Accessibility Survey

City of Downey Serapis Avenue - Telegraph Road to End

Date of Inspection
6/15/2017

Disability Access Consultants

Sidewalks , Surface : Cross Slope

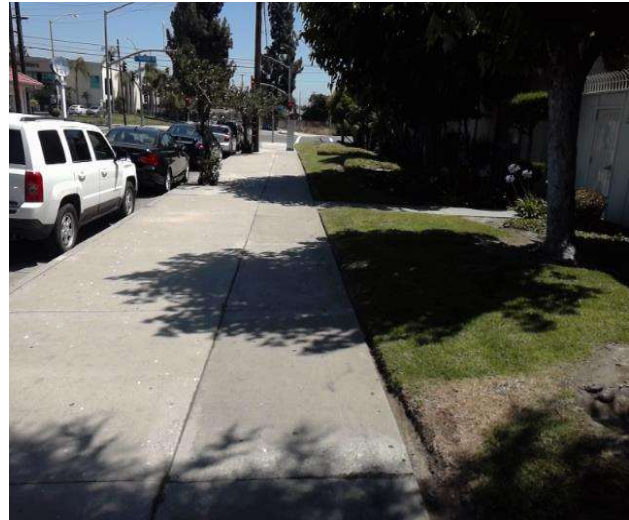
Sidewalk cross slope is not compliant.

On-Site Finding 6.80 percent for 33.00 feet

Repave the sidewalk surface with the recommended cross slope.

Recommendation Up to 2.08 percent

Sidewalks , Surface : Running Slope

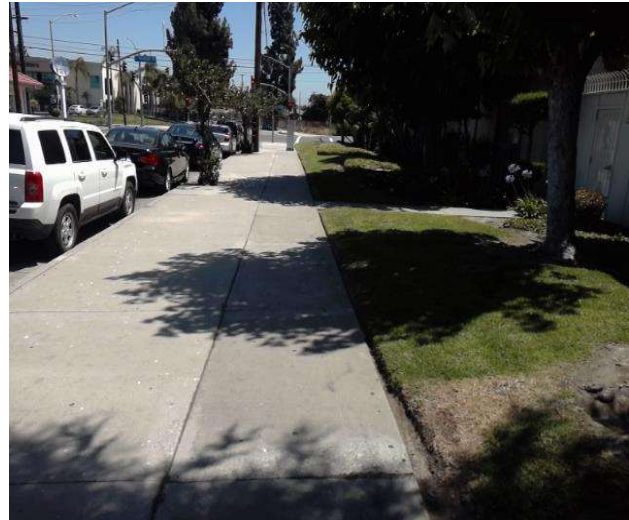
Sidewalk running slope is not compliant.

On-Site Finding 7.30 percent for 1.00 feet

Repave the sidewalk surface with the recommended running slope.

Recommendation Up to 5.00 percent

Sidewalks , Vehicular Traffic : Cross Walks and Detectable Warnings

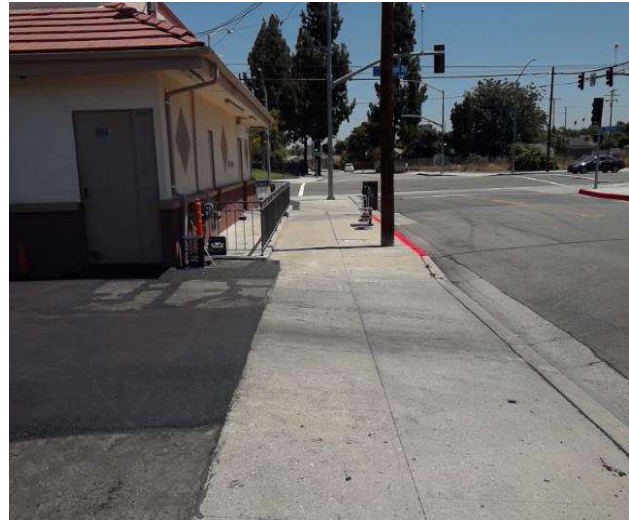
There are no detectable warnings where the pedestrian route crosses vehicular traffic.

On-Site Finding Not Found

Provide detectable warnings.

Sidewalks : Vehicular Traffic Cross Slope

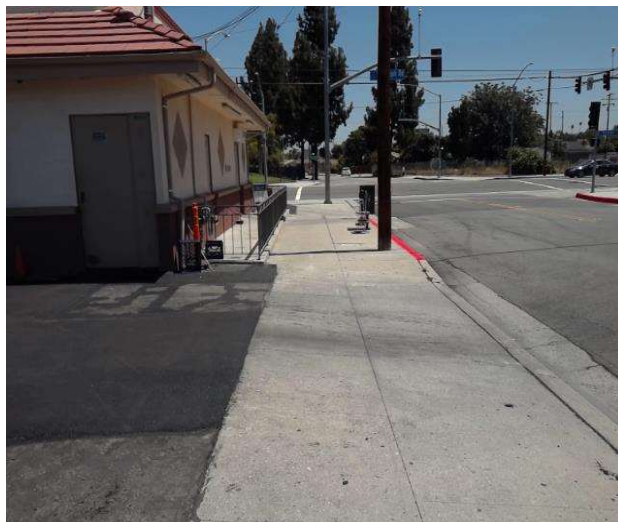
Cross slope at vehicular traffic is not compliant.

On-Site Finding 11.60 percent

Repave the surface to provide a compliant cross slope.

Recommendation Up to 2.08 percent

Sidewalks : Turn Area

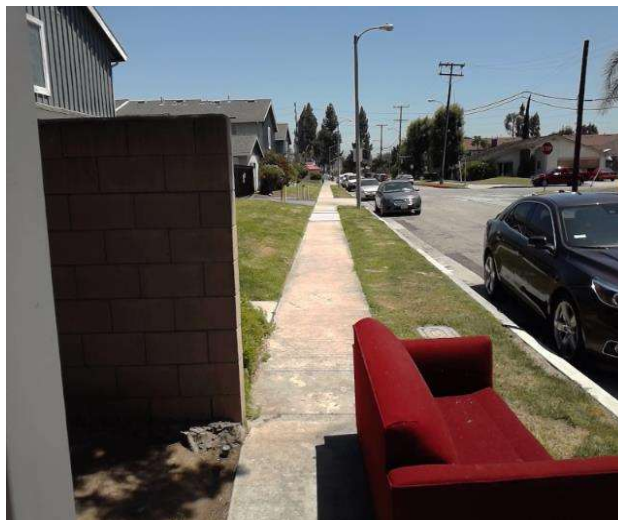
Turn area is not level.

On-Site Finding Not Level

Make sure that the turn area is level.
